Case 1

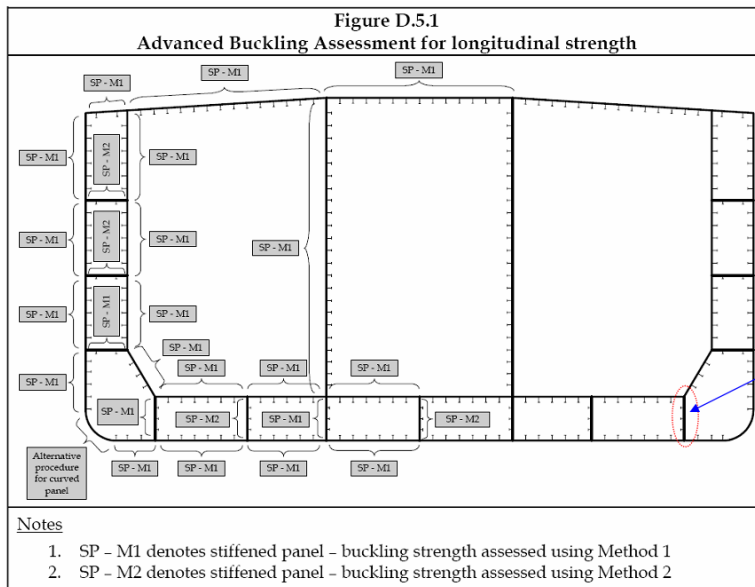
1.1

In case of snapped stiffener is applied at side girder, which method should be applied?

SP-M1 with snapped stiffener, SP-M2 with snapped stiffener, UP-M1 or UP-M2 ?

Case 2

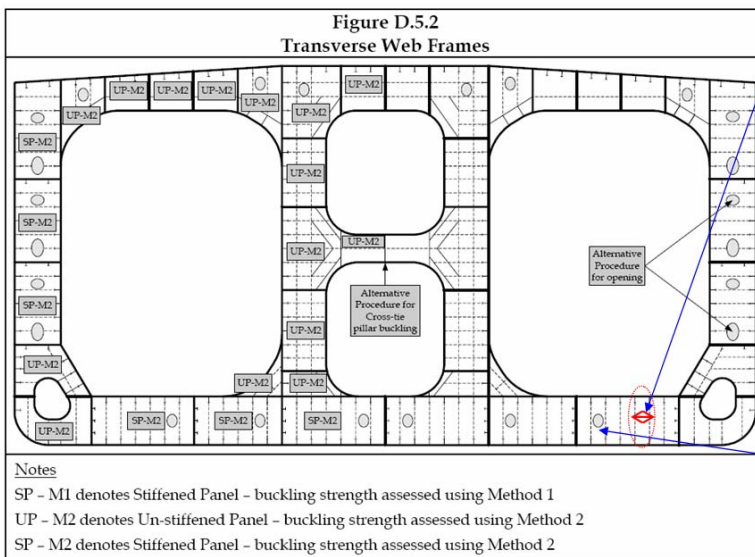
2.1

In case of additional buckling stiffener is applied at floor. Which method should be applied?

2.2

And other buckling panels at the same stiffened panel SP-M2 with stiffener number of 6 is acceptable?

2.3

If opening is not modelled and net thickness is recuded based on Table B.2.2 in App2.

How to do buckling assessment with this buckling panel?

Case 3

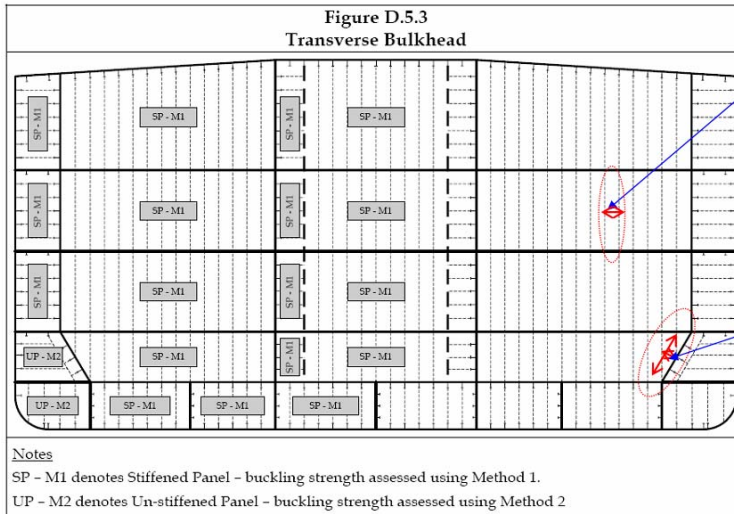
3.1

In case of additional buckling at Bulkhead. Which method should be applied?

SP-M1 with secondary stiffener, UP-M2 or UP-M1 ?

3.2

If stiffener is installed as shown, which method should be applied?

SP-M1, UP-M2 or UP-M1 ?
